**THE**  
**CROSSVINE**

**THE CROSSVINE PDD**  
**5th AMENDMENT**  
**04-09-2021**

## **The Crossvine PDD Fifth Amendment**

**EXHIBIT 1**

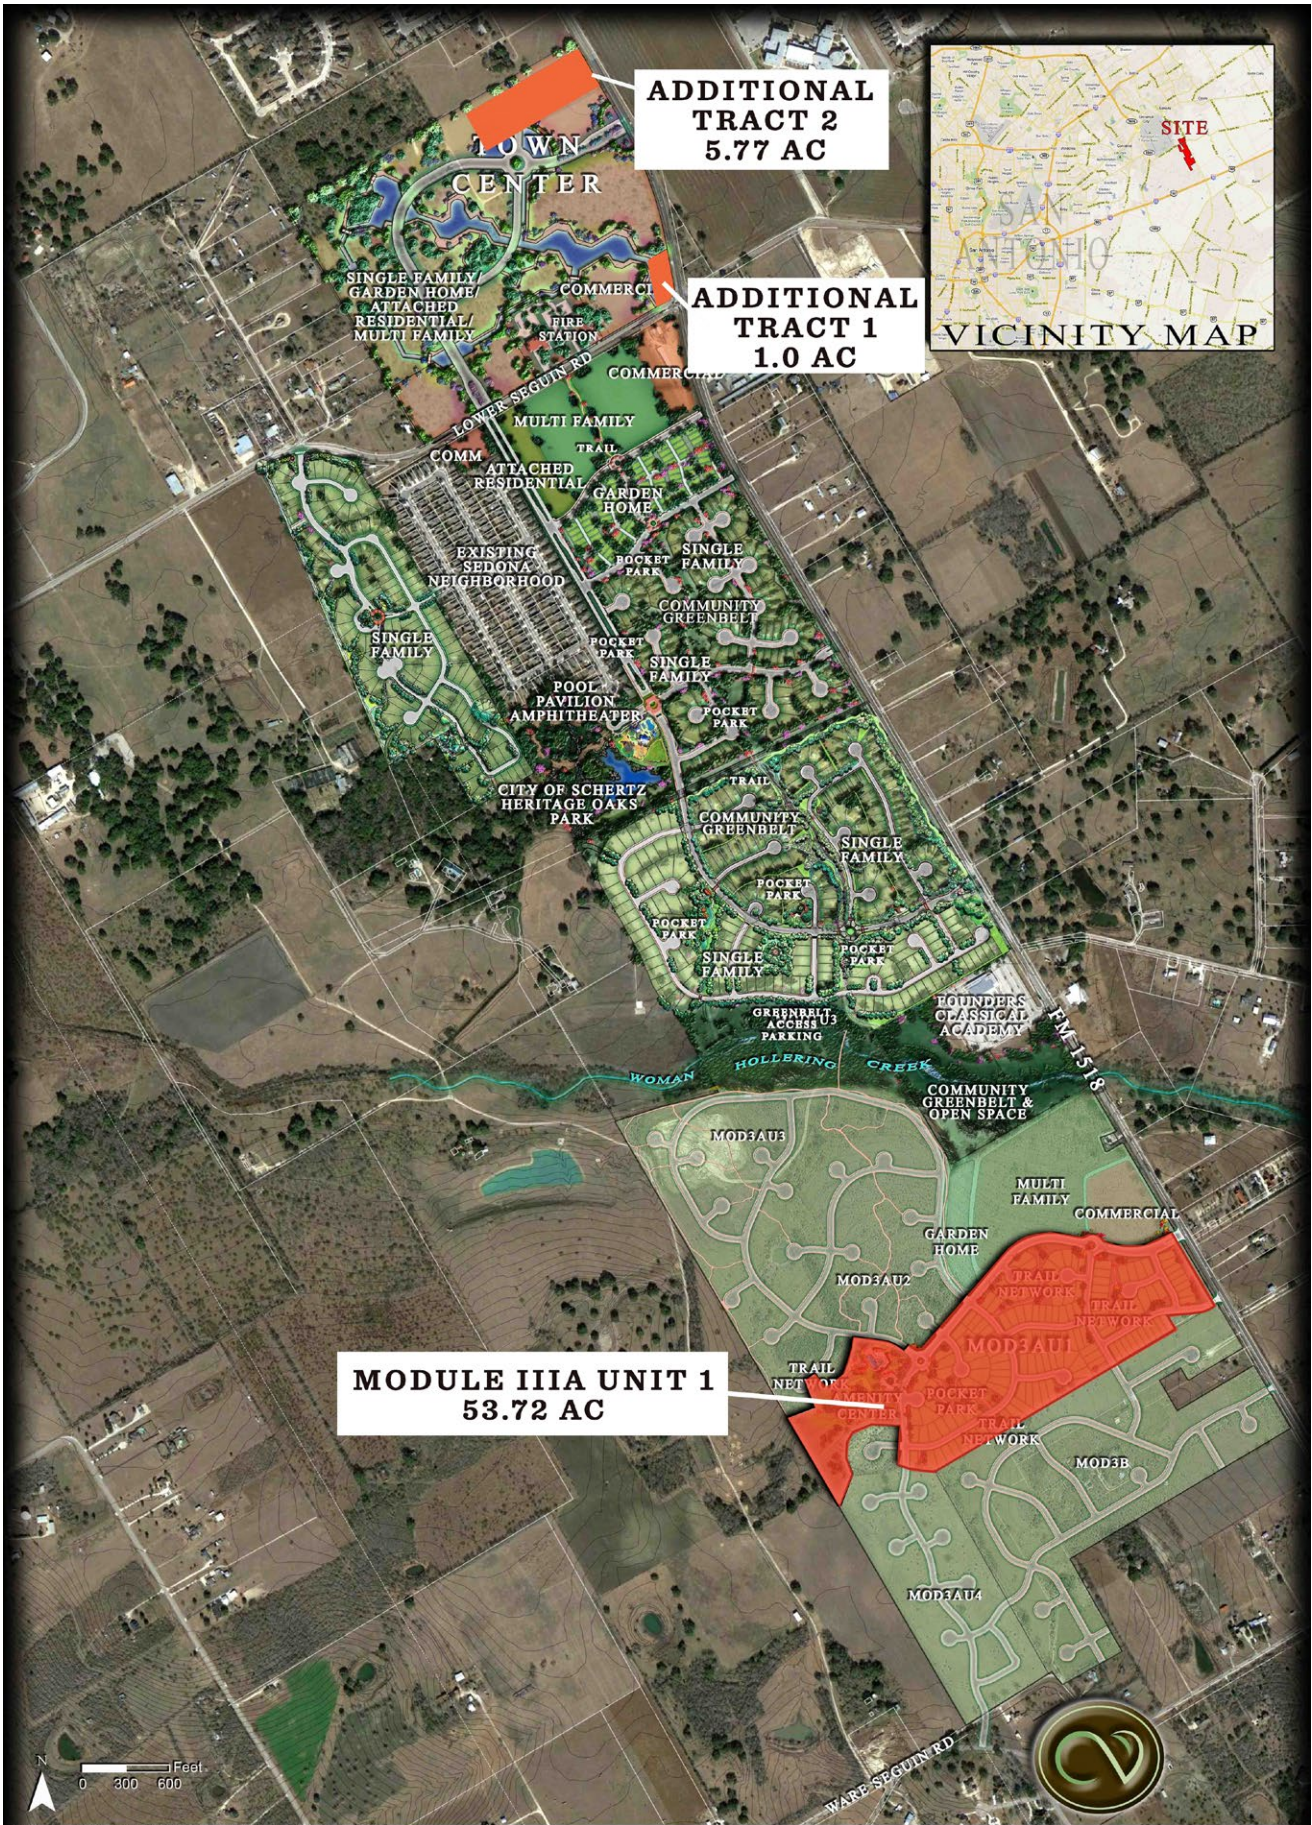
This Fifth Amendment and its specific terms, conditions, or requirements shall be applicable to Module IIB and to Module IIIA of The Crossvine PDD Project Area. Those parcels graphically depicted on Exhibit 1 and identified as Additional Tract 1 and Additional Tract 2 are being added to The Crossvine PDD Project Area by this Fifth Amendment. The legal descriptions for Additional Tract 1 and Additional Tract 2 are included herewith as Exhibit 2 and Exhibit 3. Exhibit 1 also graphically depicts and identifies Module IIIA Unit 1, which was originally part of The Crossvine PDD Project Area as reflected in Ordinance 12-S-01. The legal description for Module IIIA Unit 1 is included herewith as Exhibit 4.

This Fifth Amendment in its applicability to Module IIB is primarily to include Additional Tract 1 and Additional Tract 2 into The Crossvine PDD Project Area and to make the entire The Crossvine PDD applicable to such Additional Tracts. The remainder of this Fifth Amendment is primarily focused on the development of Module IIIA Unit 1 and the terms and conditions hereof shall apply to Module IIIA Unit 1 unless the text herein clearly designates a more restrictive or more expansive application of the terms of this Fifth Amendment.

“The Crossvine PDD Project Area” (hereinafter so called) is expanded by this Fifth Amendment to include two (2) additional tracts of land. Briefly described, the additional included tracts (collectively, the “Additional Tracts”) are:

1. A 1.00 acre tract graphically identified in *Exhibit 2* (“Additional Tract 1”).
2. A 5.77 acre tract graphically identified in *Exhibit 3* (“Additional Tract 2”).
